Montgomery Planning

01/26/2023

Rustic Roads Functional Master Plan Update

Work Session #2

Google Street View of West Hunter Road

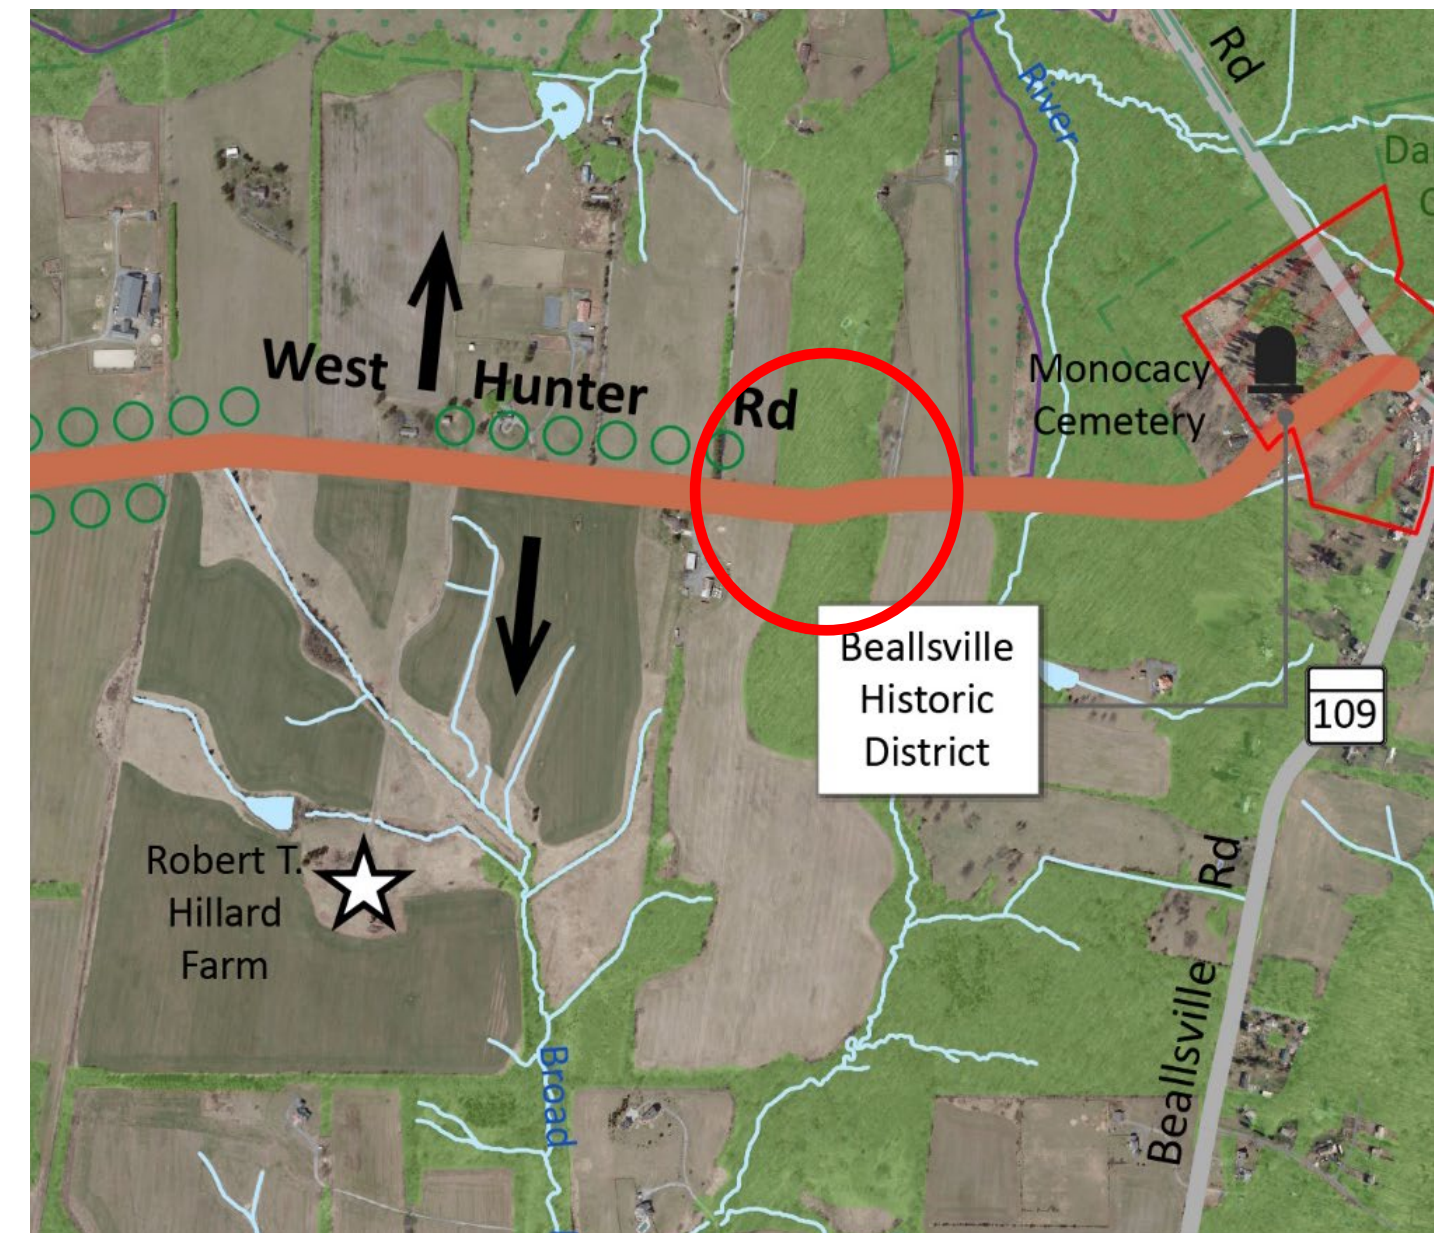
- Add roadside vegetation and mature forest east of Hillard Farm on south side of road as significant features. (RRAC)
- Previous work under utility lines took vegetation down to the ground. (RRAC)

- Add a significant feature: “Forested areas on both sides of the road east of Hillard Farm”.

Google Street View of Barnesville Road east of Peach Tree Road

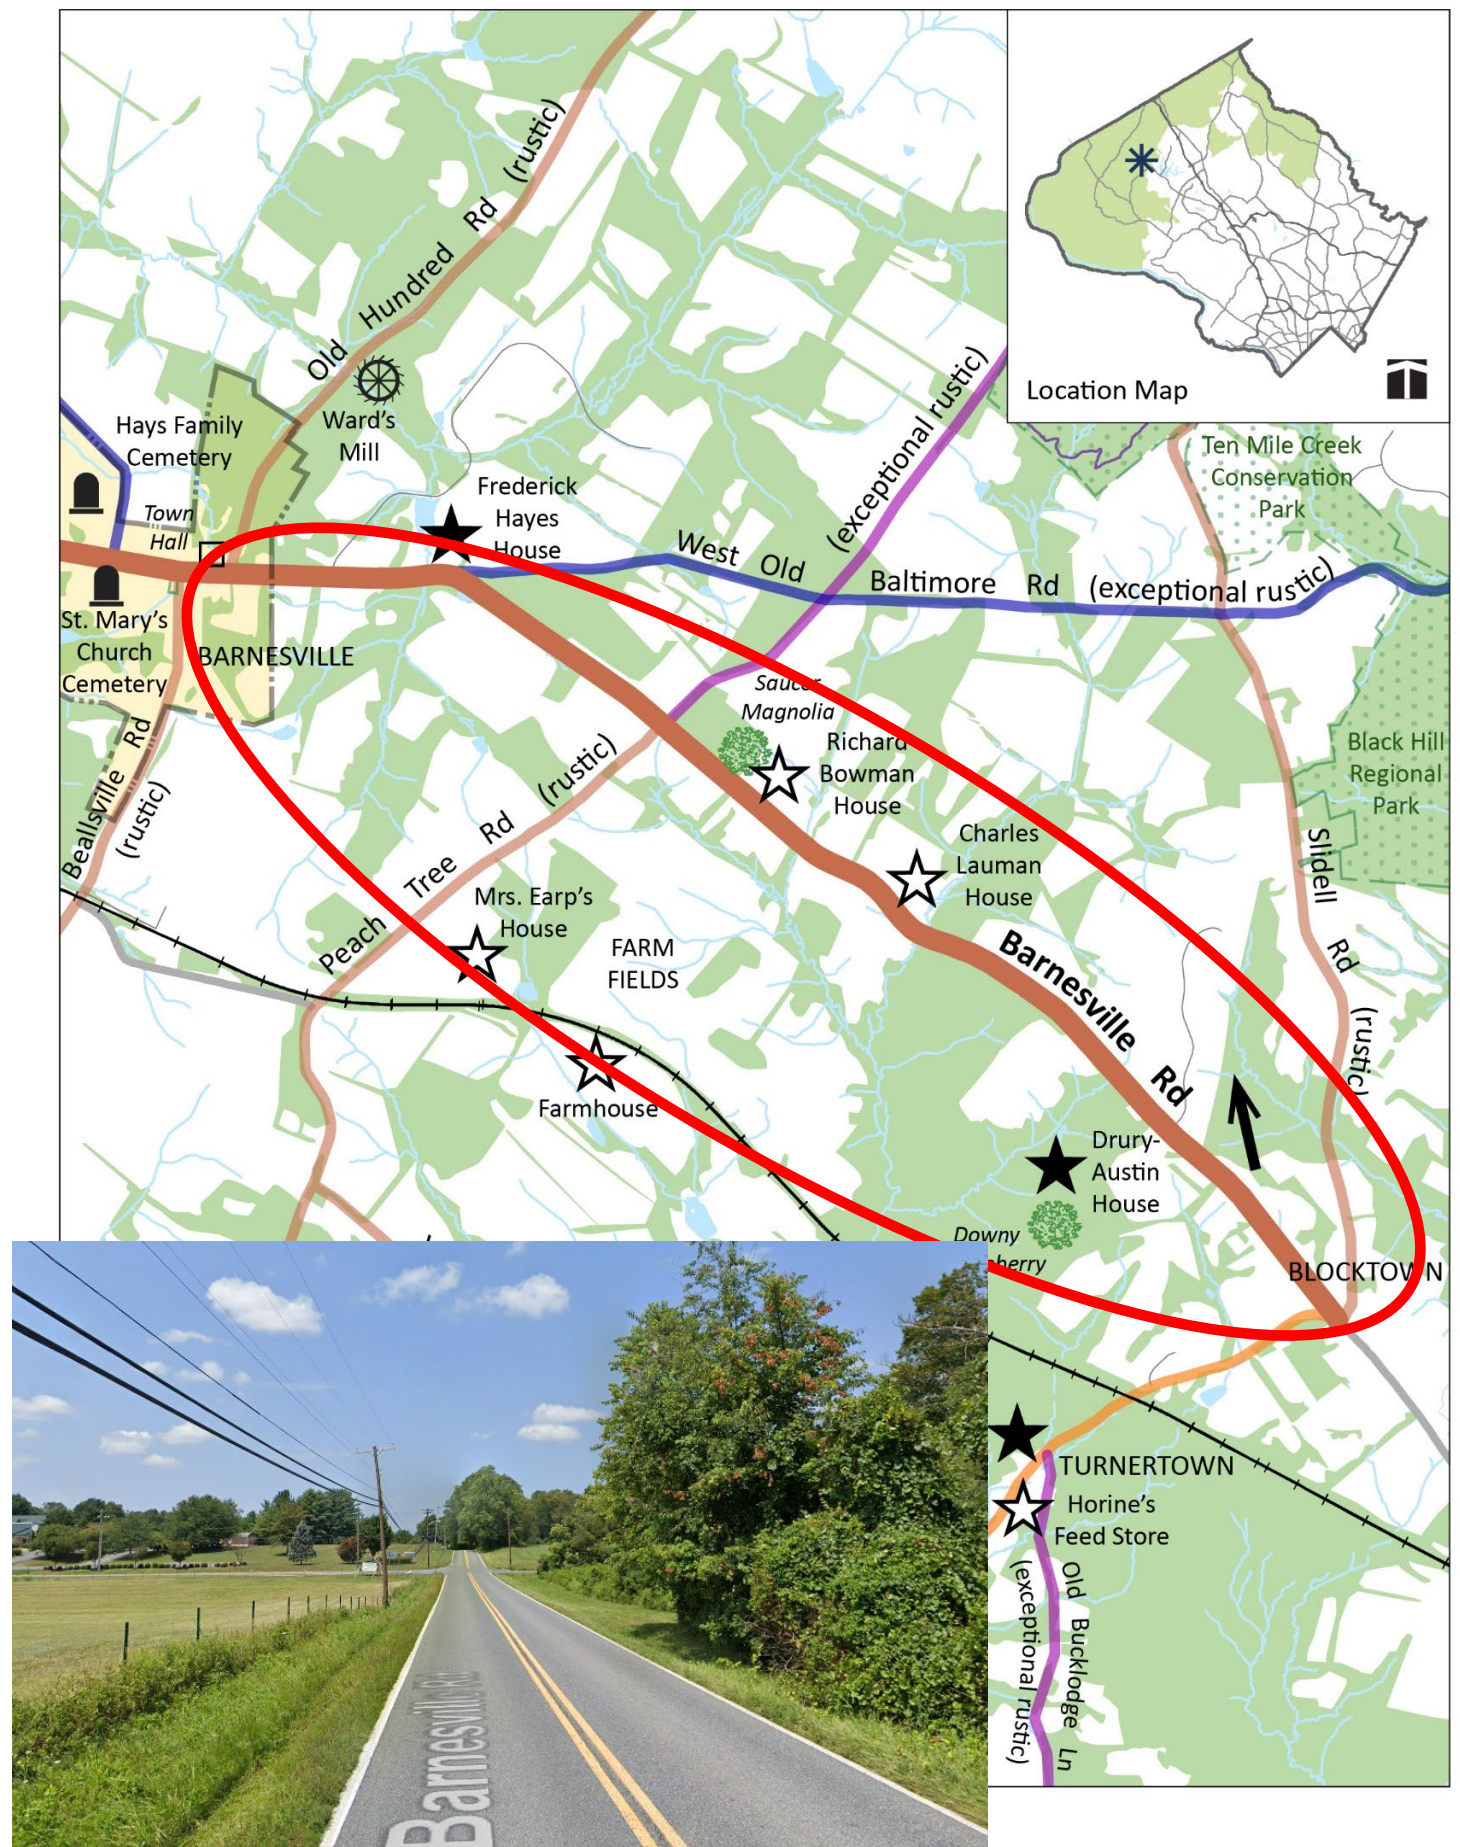
- Verify that Barnesville Road meets the requirement that it is “intended for predominately local use” east of MD 109 (Old Hundred Road). (MCDOT)

- Retain this portion of Barnesville Road in the Rustic Roads Program.

- The road was designated rustic in 1996 and provides views to rolling farmland and Sugarloaf Mountain.
- The road is intended to serve homes and businesses in the area. Other roads in the area serve regional traffic.

Google Street View of Kings Valley Road

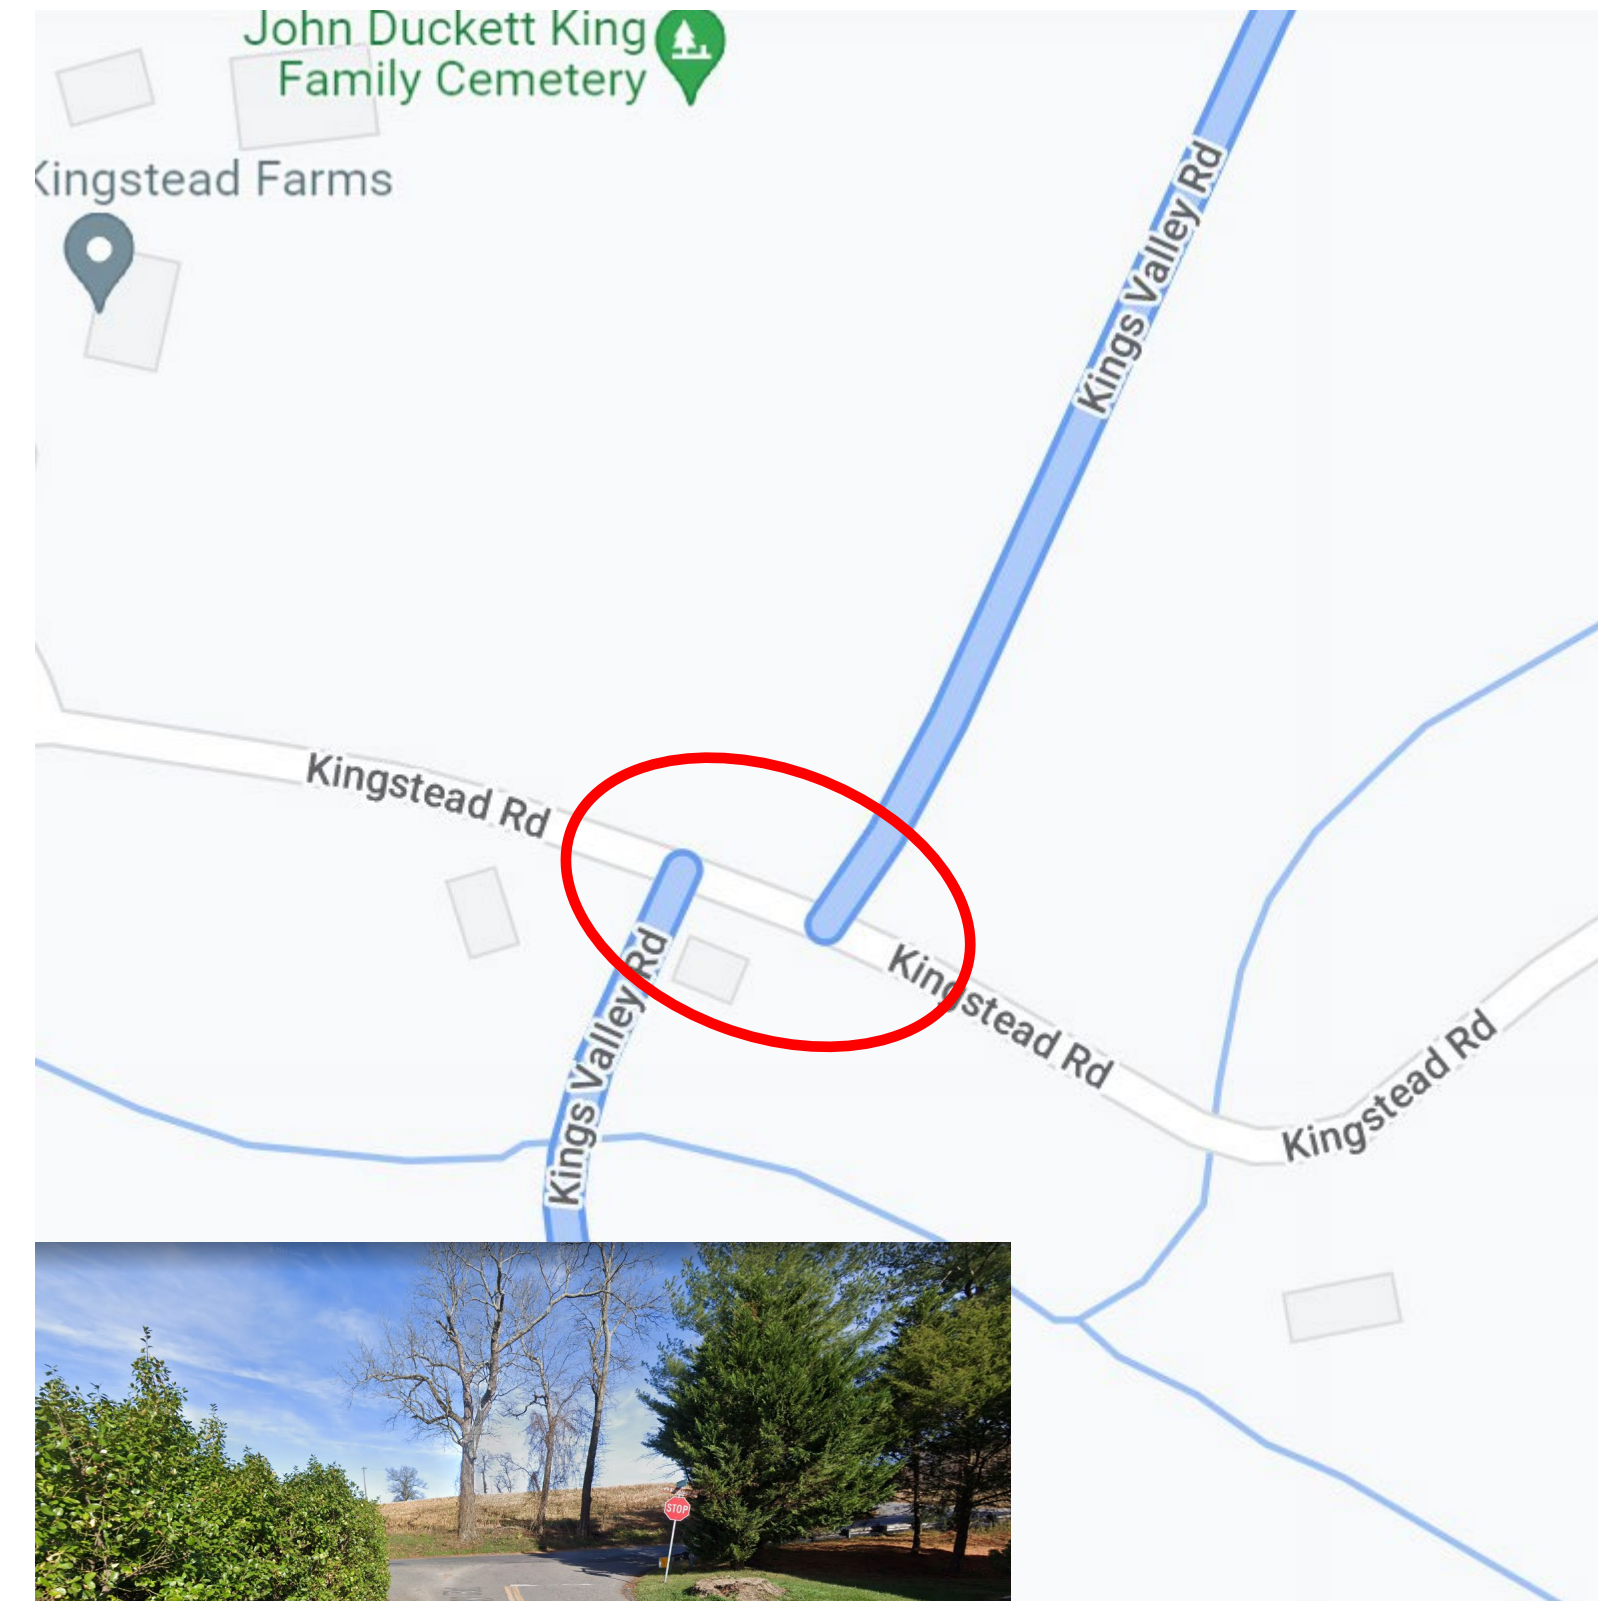
- Change the wording of the significant feature from “historic alignment” to “historic alignment including a jog in the road at Kingstead Road”. (RRAC)

- Retain current Plan text.

- The jog in the road is part of Kingstead Road.
- The Plan contains a recommendation to not realign the road at the jog (reverses a 2006 recommendation).

Google Street View of Lewisdale Road west of Haines Road

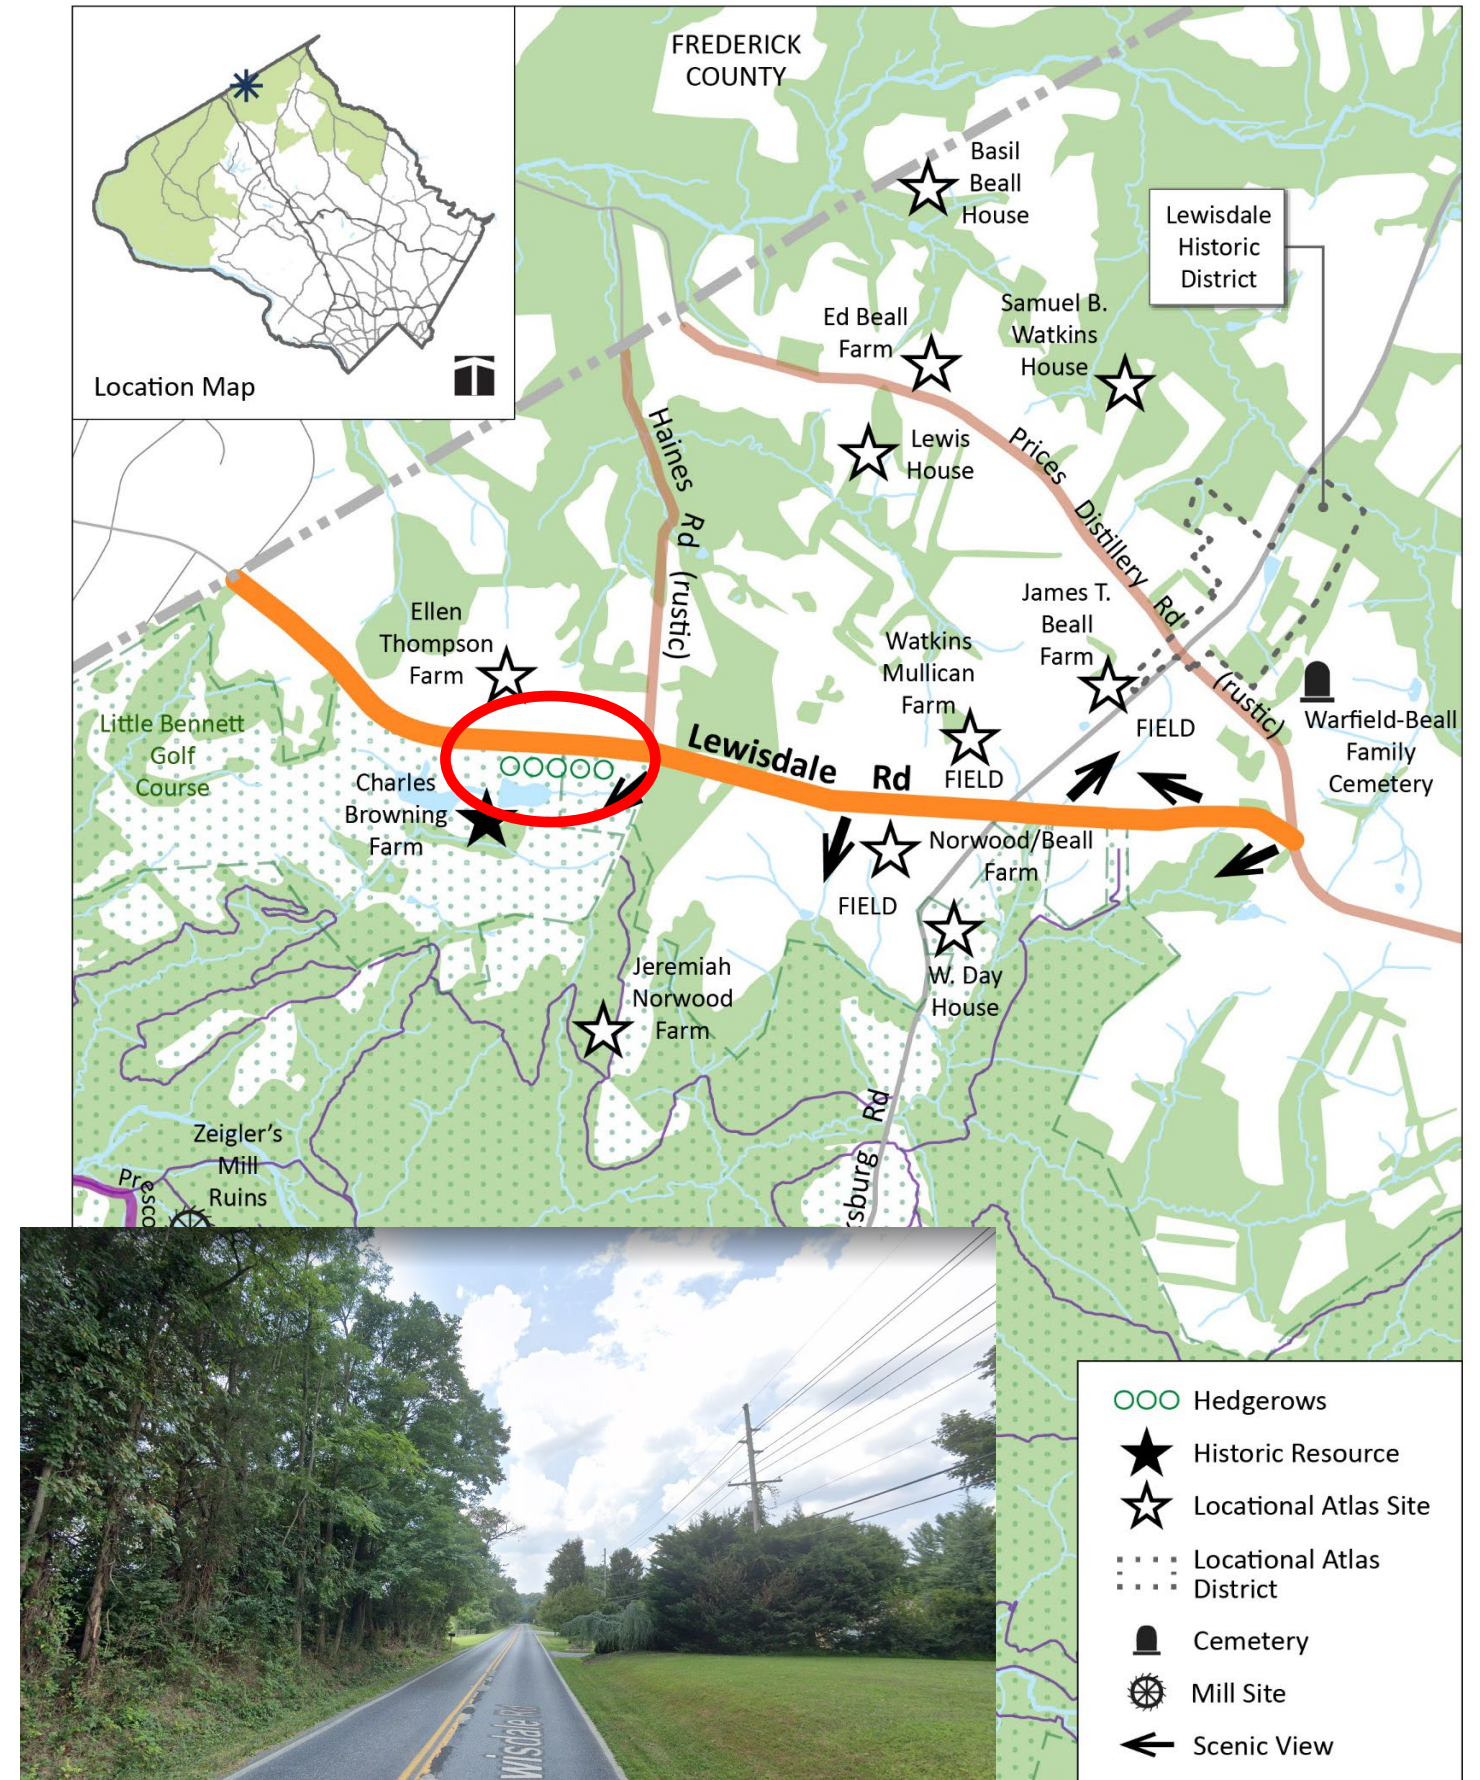
- Add hedgerows mentioned in the Traveling Experience and shown on the map to the road's significant features. (RRAC)

- Do not add significant feature.

- The hedgerows in question are a disorganized cluster of roadside plants that do not significantly enhance the traveling experience of the road. They block views of a meadow, the historic Charles Browning Farm and Sugarloaf Mountain in the distance, all on the south side of the road.
